Ground Water Consultants, LLC

March 26, 2019

Re: Review of Aquifer Impact Assessment for C.A. Skiles Family Partnership, Ltd. Permit Application – Three (3) Proposed Simsboro Wells for the Harlan Farm in Robertson County, Texas

Source: Aquifer Evaluation Prepared for C.A. Skiles Family Partnership, Ltd., March 5, 2019

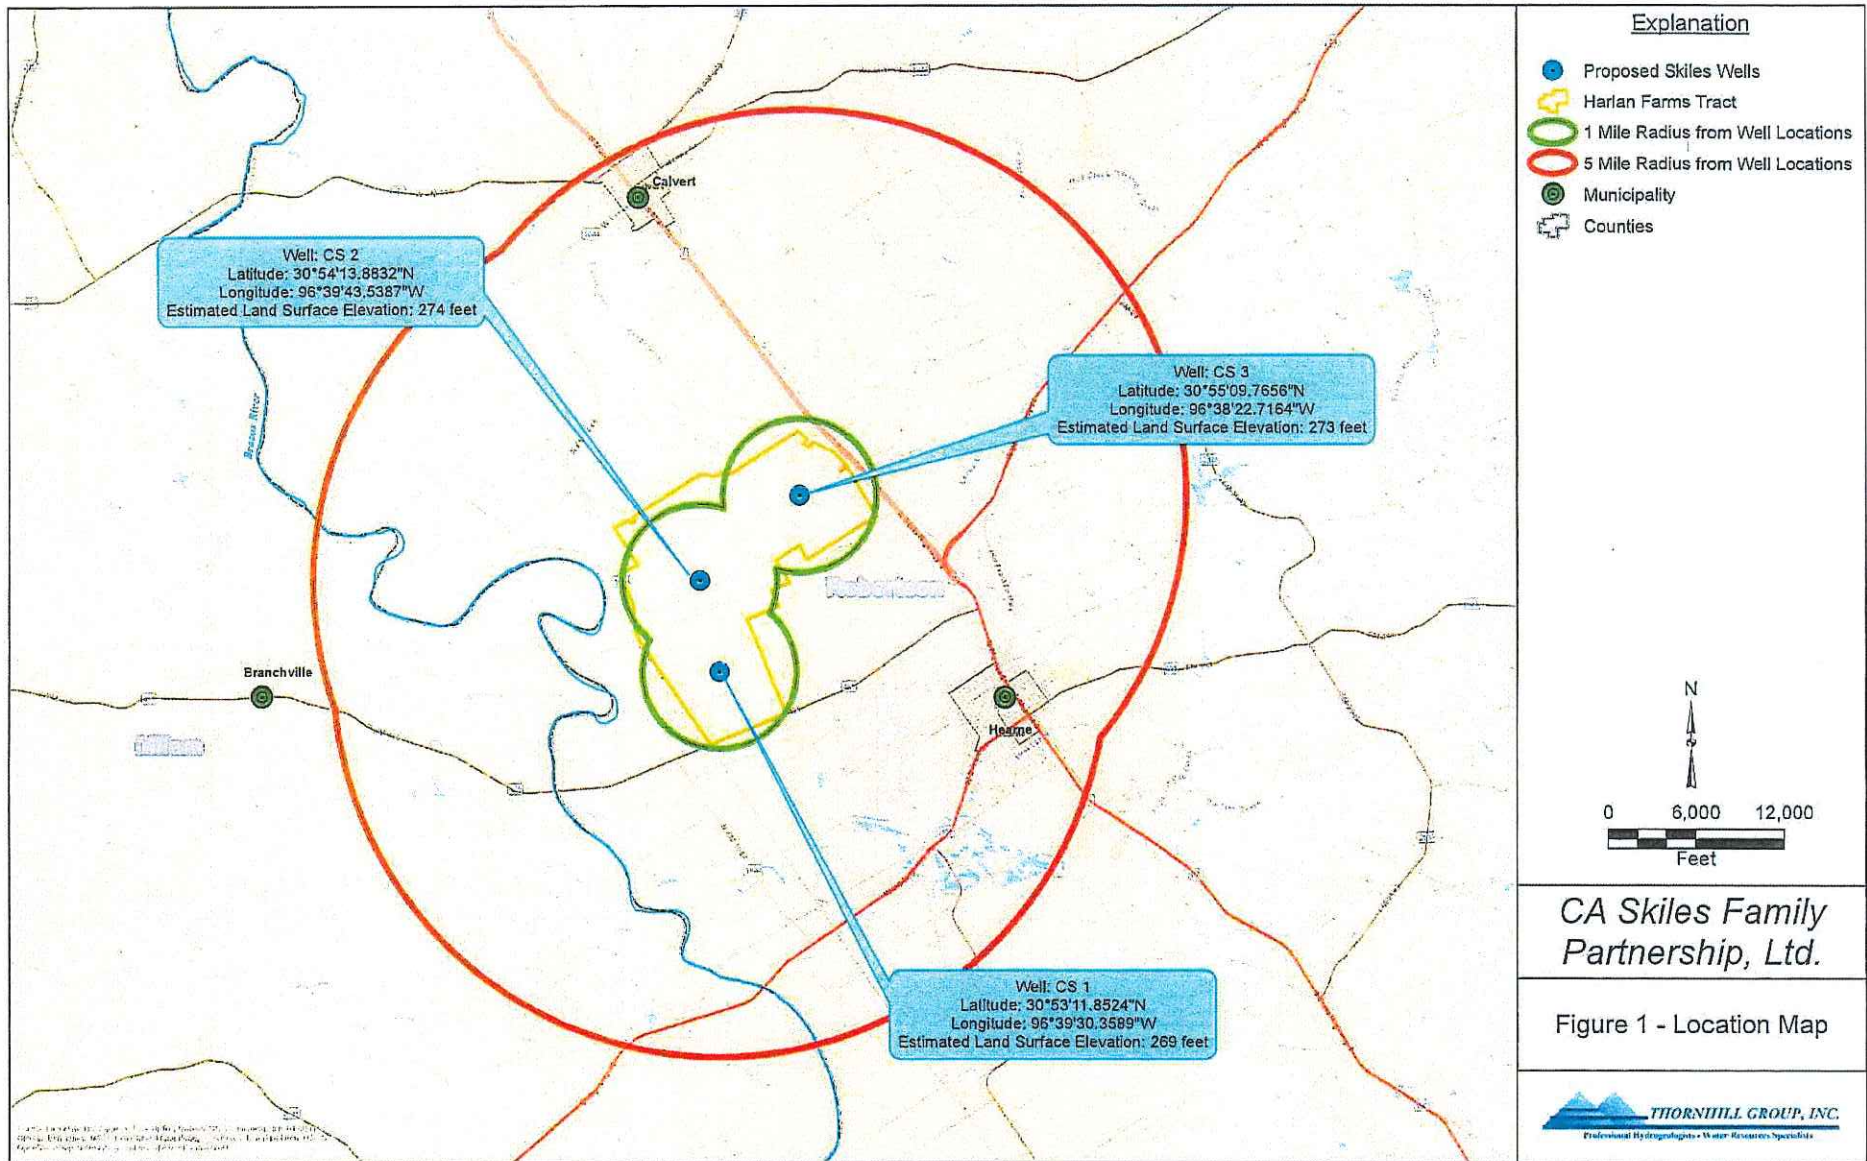
The permit application for the three wells is for an overall withdrawal amount of 15,483 ac-ft/yr, which is equivalent to an average pumping rate of about 9,600 gallons per minute (gpm) continuously for one year. The proposed pumping rates of the wells range from 3,000 to 3,300 gpm. The proposed locations for the wells are shown on the attached figure, which was provided as part of the hydrogeological evaluation report.

Source: Aquifer Evaluation Prepared for C.A. Skiles Family Partnership, Ltd., March 5, 2019

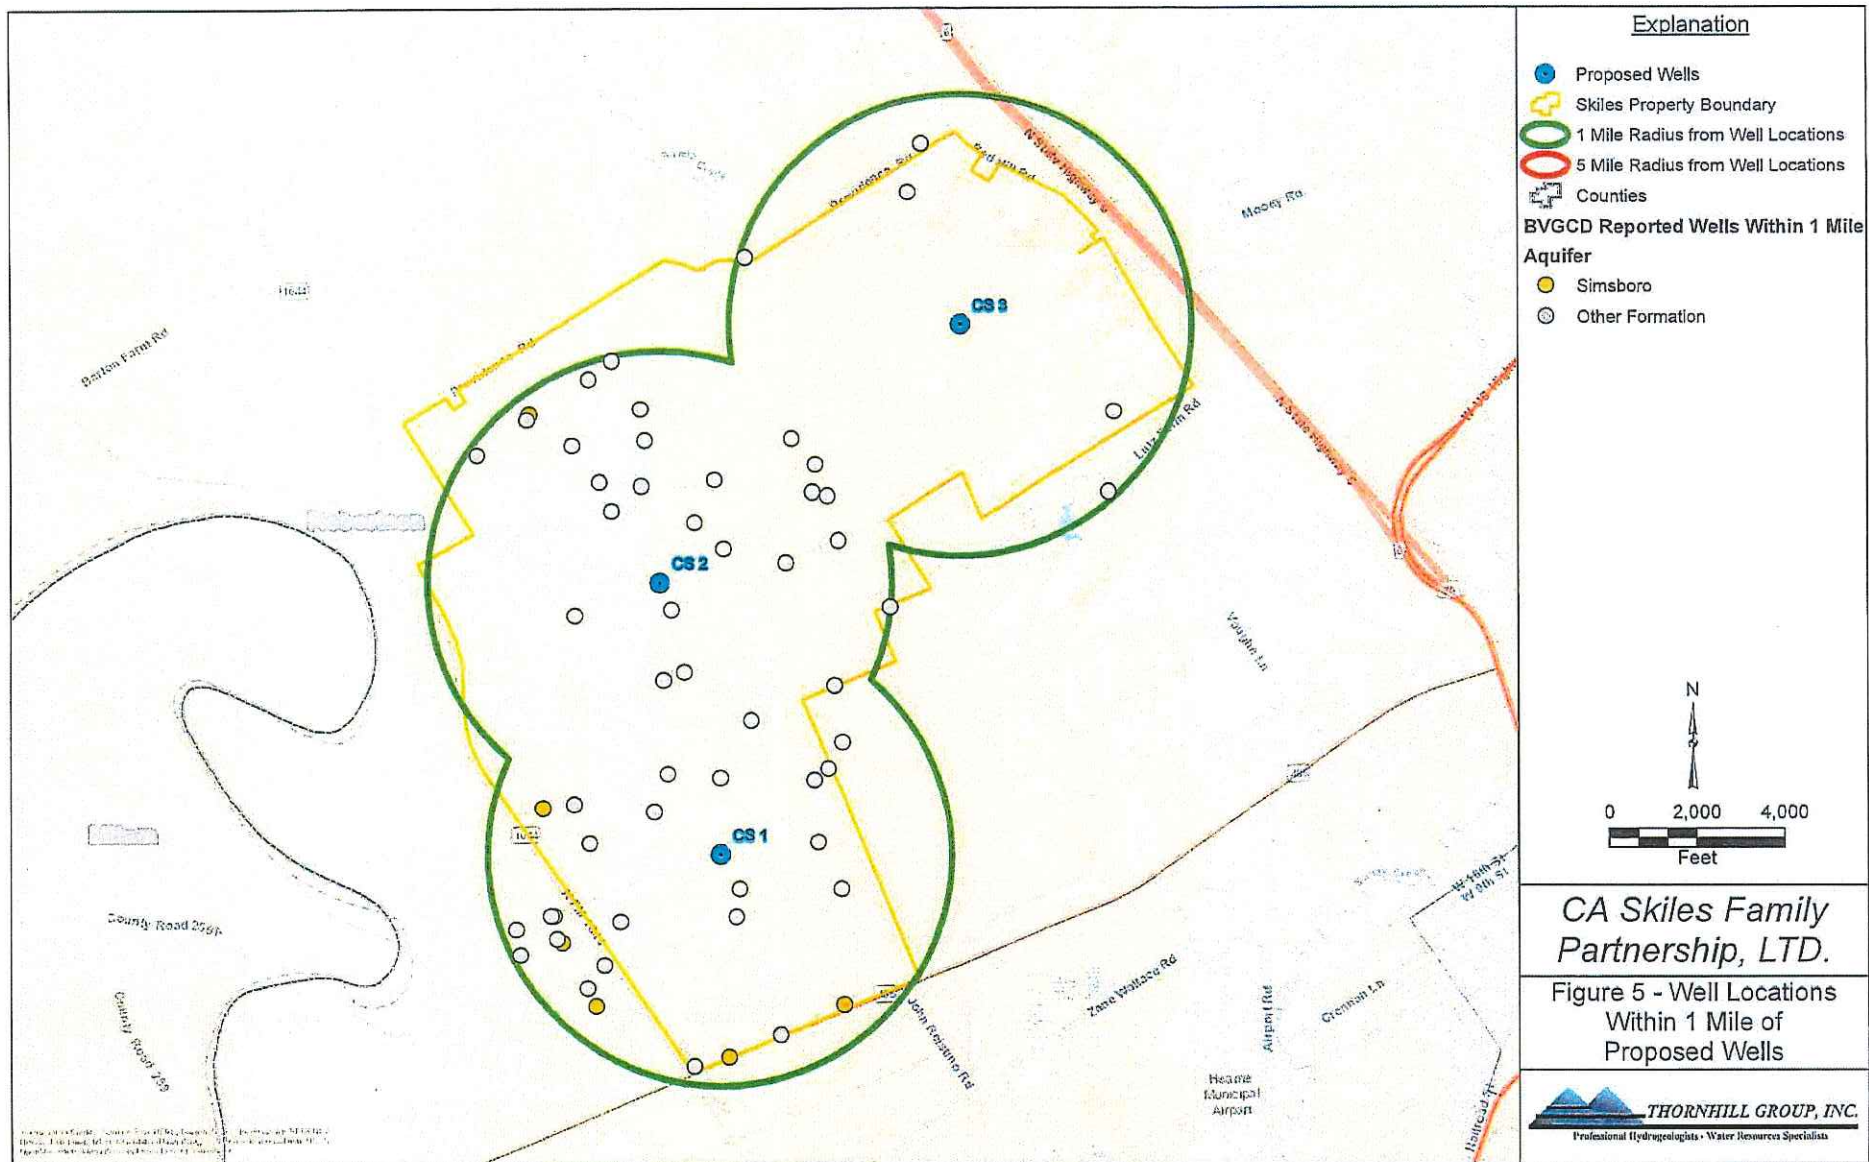
2. As required by the Rule 8.4(b)(7)(B)(2), Tables 1 and 3 are provided in the report regarding water wells that are located within one mile of the proposed well locations and screen the same aquifer as the proposed wells. Based on the map provided with the report there are five wells located within one mile of proposed Well CS 1 that screen sands of the Simsboro Aquifer and one well located within one mile of proposed Well CS 2. A copy of the well location map is attached. All of the wells are listed as being owned by the C.A. Skiles Family Partnership, Ltd.
